B Design

The design for this application has been developed in collaboration with LB Camden planning authorities through pre-application process under reference 2014/3485/PRE.

Original draft design covering both 81 and 83 Bayham Street

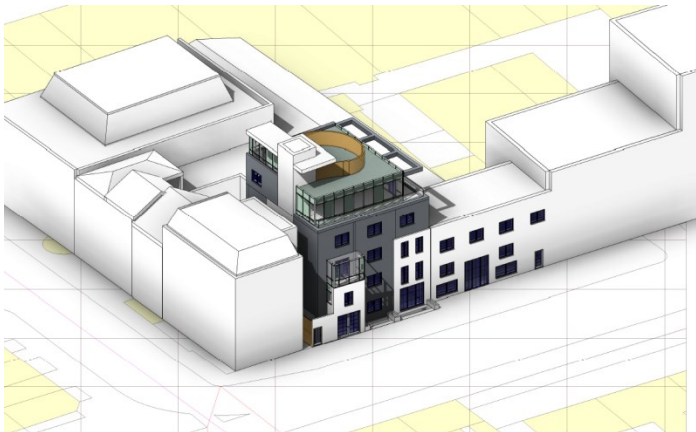
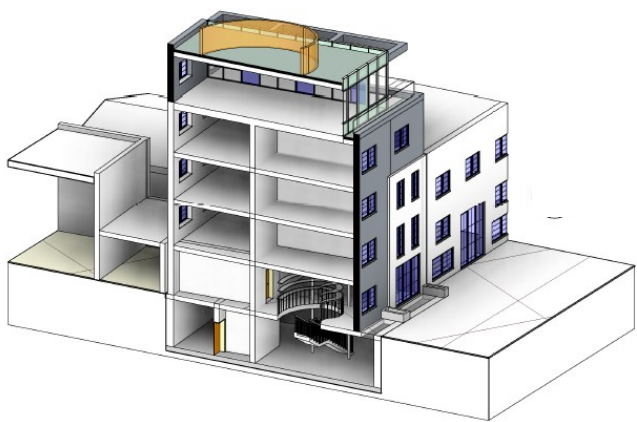
- “The current proposal would have an unacceptable impact on the character of the area due to excessive size and bulk;
- It is not appropriate to build over No. 83 Bayham Street as it is a positive contributor to the conservation area;

- It is not appropriate to extend significantly to the rear of No. 83 Bayham Street as evidenced by the recent application 2012/5288/P;
- The corner property at No. 17-19 Pratt Street must maintain its prominence as a corner building. As such it is not appropriate for the height of the proposal to extend above this building;

- There is scope for a contemporary infill element at No. 81 Bayham Street but it would have to be of the highest quality;
- There *may* be the possibility of some additional height over what has previously been approved at No. 81 (see 2007/2944/P) but only if the design provides a clear contrast with the retained building at no.83. At the meeting the possibility of stepping the building back both from the frontage and down from the adjoining building to the south were discussed as a potential method to ensure that the setting of No. 83 was not compromised. Please note that the building massing approved as part of the existing permission is considered to be about what we would normally consider acceptable;

- The proposal should not come any closer to the kitchen windows of the adjoining building to the south than that which has already been approved at No. 81.”

Graphics extracted from revised design

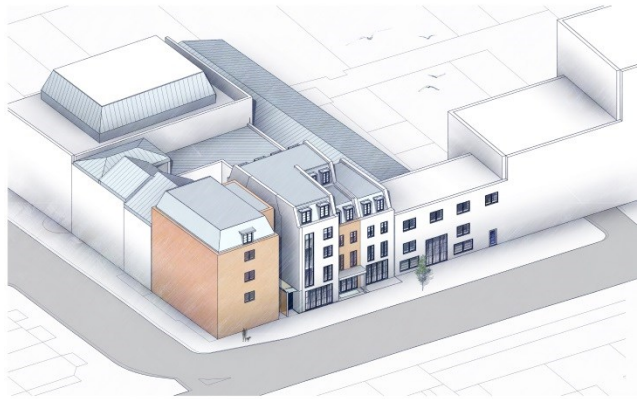
- **Comment 1:** “The current proposal would have an unacceptable impact on the character of the area due to excessive size and bulk”. **Revised proposals:** size and bulk has been significantly reduced by keeping No. 83 to the North as existing, creating a modern vertical element to the South which matches the streetscape of the adjacent building while providing a clear recessed cut between No. 83 and the southern element. Height has been reduced generally by omitting any roof access and lift overrun;

- **Comment 2:** “It is not appropriate to build over No. 83 Bayham Street as it is a positive contributor to the conservation area”. **Revised proposals:** No. 83 is to remain as existing;

- **Comment 3:** “It is not appropriate to extend significantly to the rear of No. 83 Bayham Street as evidenced by the recent application 2012/5288/P”. **Revised proposals:** No. 83 is to remain as existing;

- **Comment 4:** “The corner property at No. 17-19 Pratt Street must maintain its prominence as a corner building. As such it is not appropriate for the height of the proposal to extend above this building”. **Revised proposals:** the southern element is a modern re-interpretation of 17-19 Pratt Street streetscape with a carefully designed light curtain wall which matches the parapet height wrapped in a standing seam zinc envelope as per the adjacent mansard roof;

- **Comment 5:** “There is scope for a contemporary infill element at No. 81 Bayham Street but it would have to be of the highest quality”. **Revised proposals:** the attached design aims at revisiting the infill site with a finely detailed modernist approach including for a mixture of high quality materials which will provide contrasting masses and therefore a dematerialisation of the overall scale through a game a opacity, transparency and reflectivity. The principles are:

- with a recessed penthouse to provide transparencies and sky reflections in order to create a lightweight, background treatment effect.
- **Comment 6:** “There may be the possibility of some additional height over what has previously been approved at No. 81 (see 2007/2944/P) but only if the design provides a clear contrast with the retained building at no.83. At the meeting the possibility of stepping the building back both from the frontage and down from the adjoining building to the south were discussed as a potential method to ensure that the setting of No. 83 was not compromised. Please note that the building massing approved as part of the extant permission is considered to be about what we would normally consider acceptable”. **Revised proposals:** please refer to all above points.

- **Comment 7:** “The proposal should not come any closer to the kitchen windows of the adjoining building to the south than that which has already been approved at No. 81”. **Revised proposals:** building has been set further away than the already approved scheme to minimise impact on 17-19 Pratt Street and facilitate construction.

Alternative 1

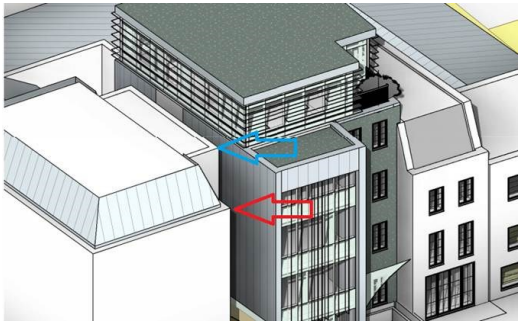
- “The retention of the positive contributor is of course welcomed;
- The height and bulk is still really problematic, rising above the mansard of the corner building and significantly stepping up from the scale of the adjacent buildings to the north is not considered to be acceptable. Please reconsider the proposal with regard to the relationship of the building with the eaves of the corner building (see red arrow in diagram below). If you still seek to consider a setback roof level, please consider with regard to the secondary eaves of the adjoining building (see blue arrow in diagram below). Please note however that we are not implying that such a setback roof level would definitely be considered acceptable at this time.

- The design of the new build is a rather odd composition, with a more traditional section juxtaposed with a very contemporary element, all topped with the very bulky modern penthouse. A contemporary approach would be acceptable given the context but it would need to be more coherent – the same architectural approach across the site would probably work better.

- The materials and fenestration pattern needs to respond better to the surrounding context – the proposed curtain walling effect does not seem appropriate in Camden Town where the buildings are generally solid masonry with punched openings.”

The design team therefore reviewed the potential options and issued to LB Camden the two alternative approaches shown to the left. Alternative 1 was issued on 16 September 2014 and considered as too much of a step back towards the currently approved scheme without resolving the bulk issue. Alternative 2, was discussed at an intermediate pre-application meeting with Hannah Walker on 10 October 2014. Minutes of this meeting are provided on the next page.

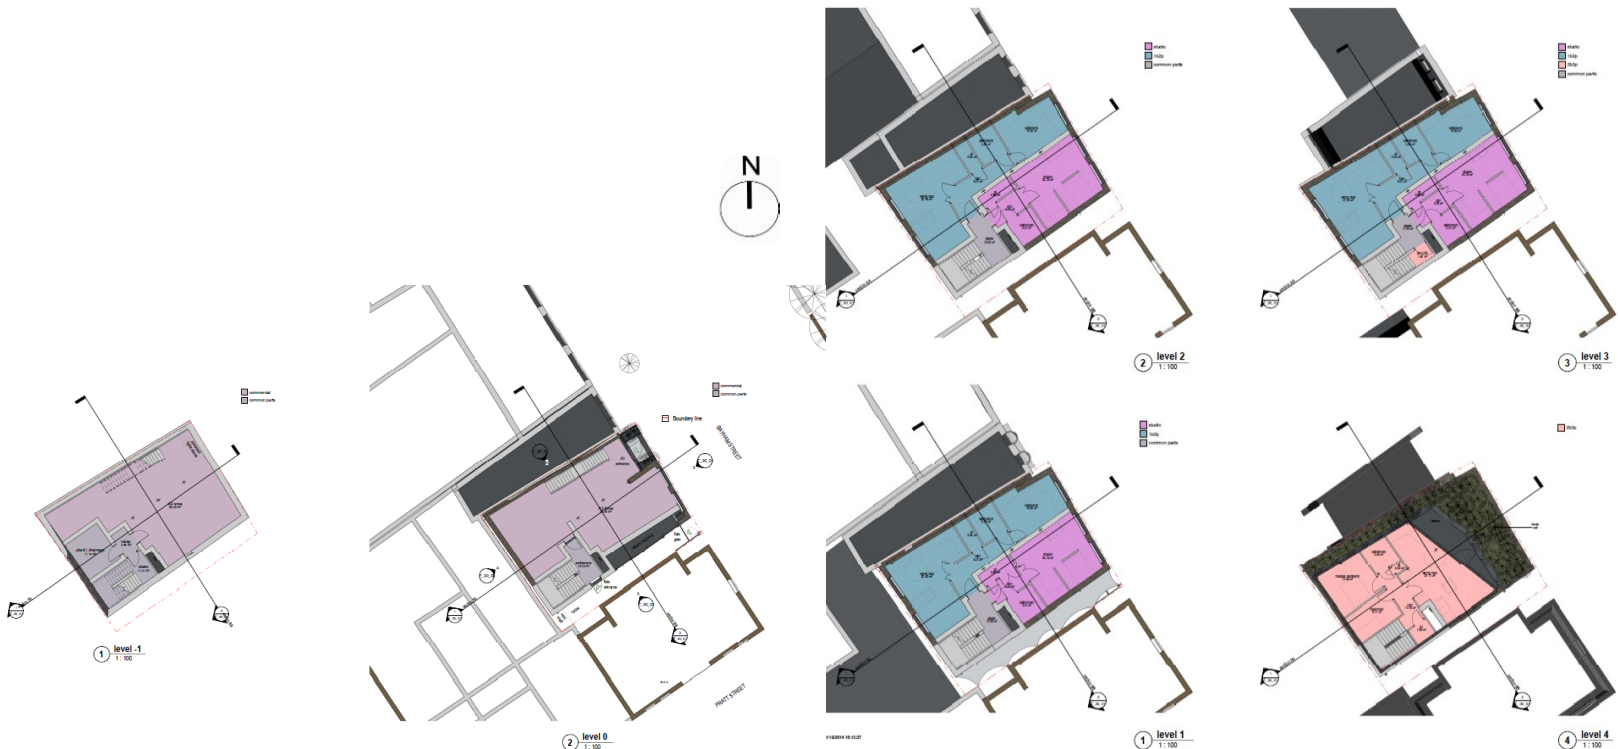
Hannah Walker (HW) requested that the staggered appearance needs adjusting. The new proposals should have a level building line. There is a need to prepare drawings showing a 'forward' building line which would be prominent of No83 Bayham Street. HW requested that the design team also examine a building line slightly 'set back' from No83 Bayham Street for the purposes of comparison. However, the consensus was that the building line should be level with the corner building, Brehon House, on the junction between Bayham Street and Pratt Street.

As a result of this re-alignment HW called for a homogeneity of design for the facade. This varied from Camden's original views on a graduated approach between Brehon House and No 83 Bayham St. It was agreed to revise the design to a 'metric' brick- finished, frontage with recessed window openings to align, where possible, with No 83. The return flank would be eliminated in this design.

Because of the envisaged changes it was agreed that we should redesign the entrance, widening it and locating it adjacent to No 83. The entrance should have a light feel and match, in style, the pavilion.

HW appreciated the new design to the pavilion, particularly the removal of a 'mansard' at the front. However, she was concerned about the front elevation of the pavilion and its positioning. HW requested a redesign to improve the relationship between the new main facade and the 'glazed' appearance of the pavilion. She accepted the 'waisted' footprint of but suggested that we might look at widening this slightly to accentuate the step between Brehon House and No83 Bayham Street. However, she also felt that we had exaggerated the 'set back' from the main building line. She emphasised that the overall height must remain consistent with Brehon House in designing the changes.

The massing and proportions of the proposals, including the basic floor plans and unit sizes were not at issue. The front building line needs regularising. The overall height needs adjusting through a redesign of the pavilion to match the front entrance and the new facade.
